Applicant: Madelyn Nierengarten; CenterPoint Energy
Consultant: Monica Entinger; Merjent, Inc.
Project: Natural Gas Pipe Replacement
Location: Willow Creek Road: Eden Prairie
Applicable Rule(s): 2, 4, 5, and 6
Reviewer(s): Louise Heffernan and Bob Obermeyer; Barr Engineering Co.

CenterPoint Energy is proposing to replace 205 lineal-feet of 2-inch plastic natural gas pipeline along Willow Creek Road in Eden Prairie. The pipe installation will be installed by directional boring and will cross the South Fork of Nine Mile Creek (Creek). The replacement pipe at the Creek crossing will be a minimum of 10-feet beneath the bottom of the Creek. At this location, the Creek provides the outlet for Bryant Lake. The directional boring pits for the Creek crossing will be a minimum distance of 100-feet from the centerline of the Creek. The southern boring pit will be located at an approximately elevation of 851.2 M.S.L., 4.3 feet below the 100-year frequency flood elevation of 855.5 M.S.L. for Bryant Lake and the Creek.

Figure 2: Site Plan
Willow Creek Rd & Bryant Lake Dr Project (WO# 103231276)
 CenterPoint Energy
 Eden Prairie, Hennepin County, Minnesota

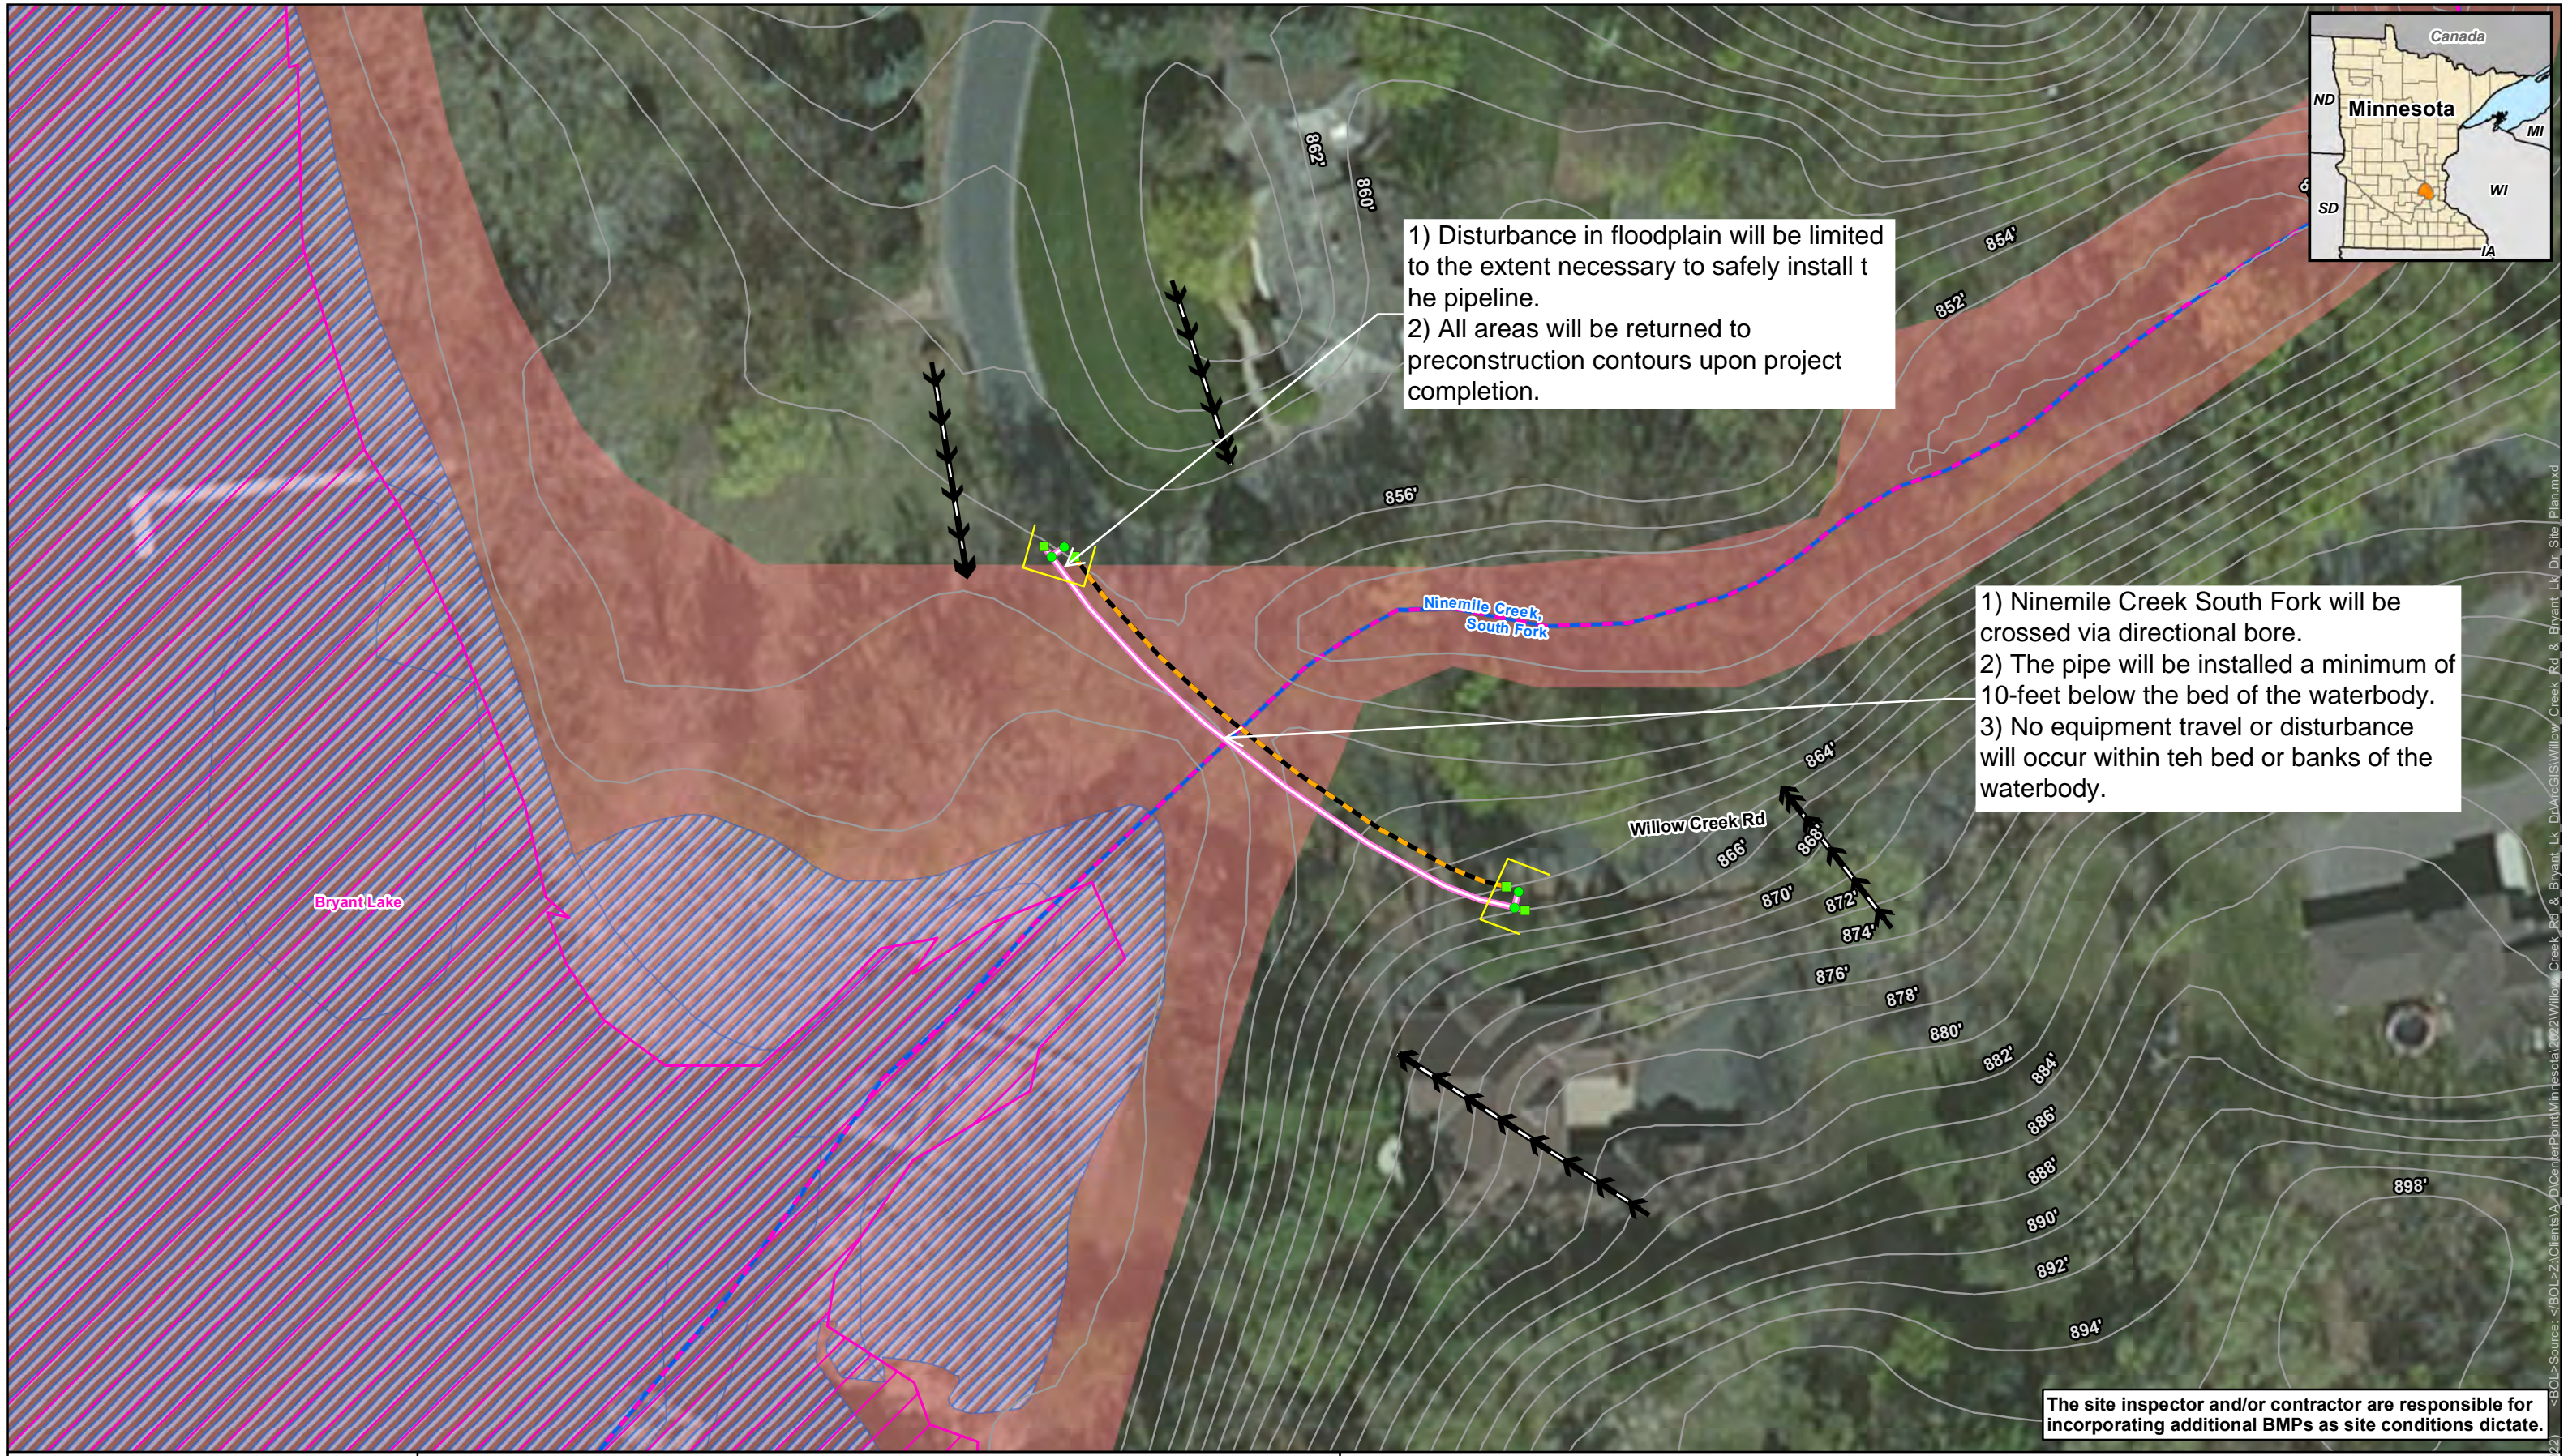
Per Rule 4.5.6, an as-built drawing of the floodplain areas disturbed and restored conforming to the design specifications as approved by the district.

1) Disturbance in floodplain will be limited to the extent necessary to safely install the pipeline.
 2) All areas will be returned to preconstruction contours upon project completion.

1) Ninemile Creek South Fork will be crossed via directional bore.
 2) The pipe will be installed a minimum of 10-feet below the bed of the waterbody.
 3) No equipment travel or disturbance will occur within the bed or banks of the waterbody.
